Product Change Description

Model Name: T6831
HW: V1.0
SW: V3.0.4
FCC ID: 2AH25T6831

Model Name: T6F10
HW: V1.0(LA+EU)
SW: V3.0.0
FCC ID: 2AH25T6F10

SOFTWARE MODIFICATIONS:

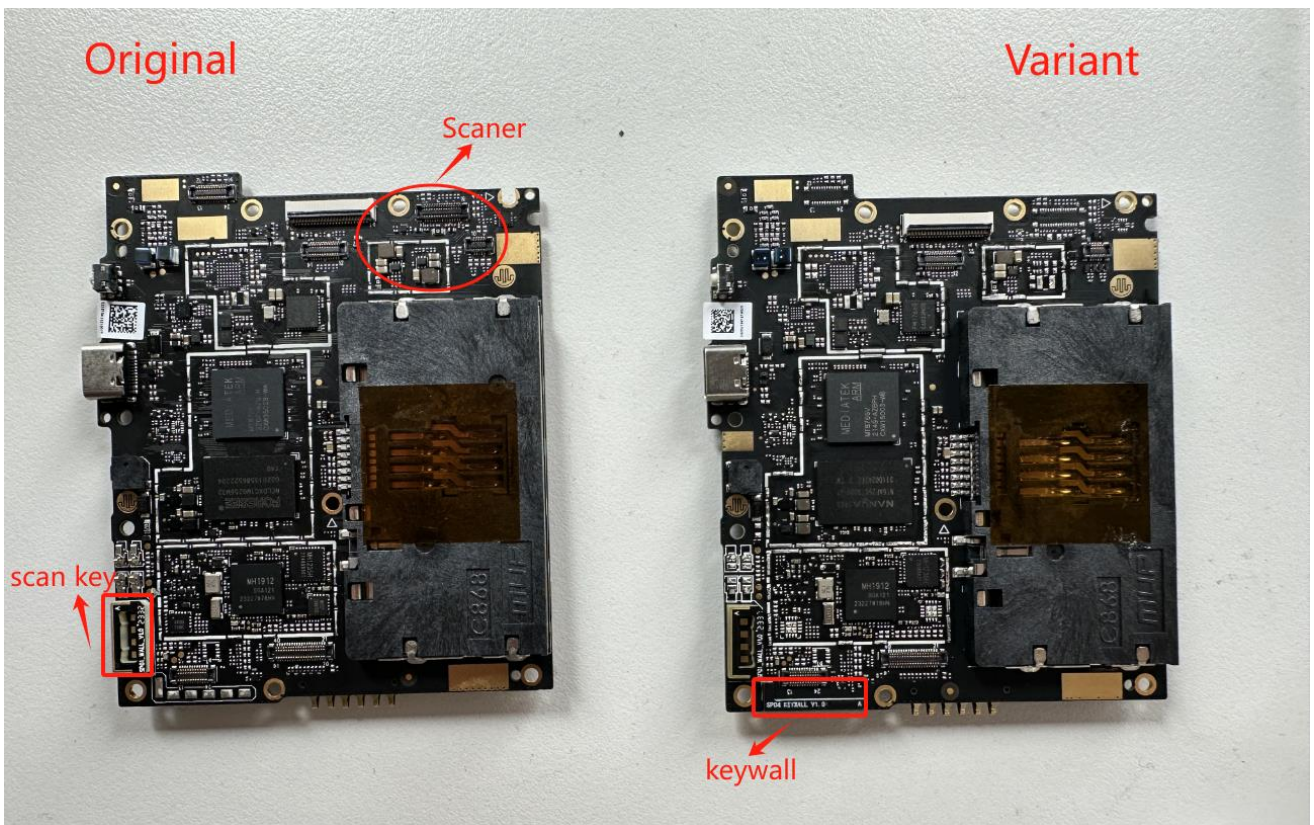
Protocol Stack changes: NO
MMS/SUPL changes: NO
STK/USAT changes: NO
Browsing changes: NO
Other changes detailed: Optimize functions, solve bugs, and iterate software versions. Iterative software upgrades do not affect RF performance.

Other changes detailed:

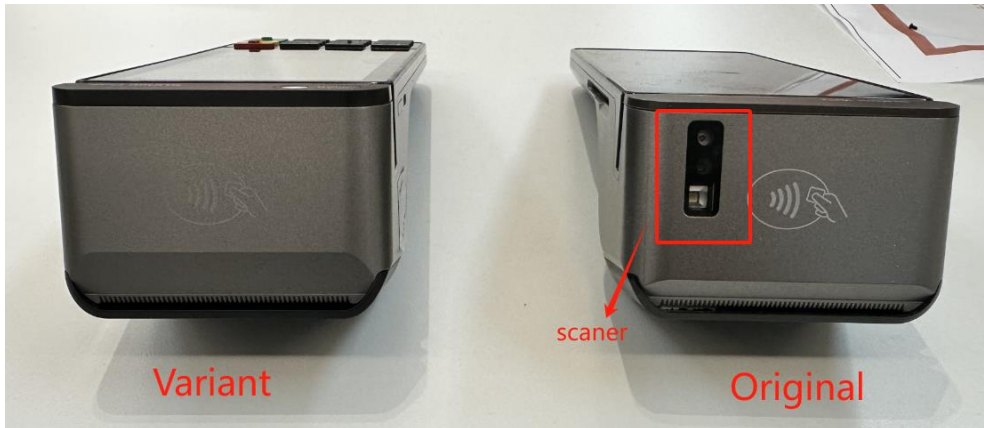
Use new metal front/back cover or keypad: YES

Mechanical shell changes: YES

- 1.No scanner.
- 2.The position of the front camera is different.
- 3.Add keyboard.
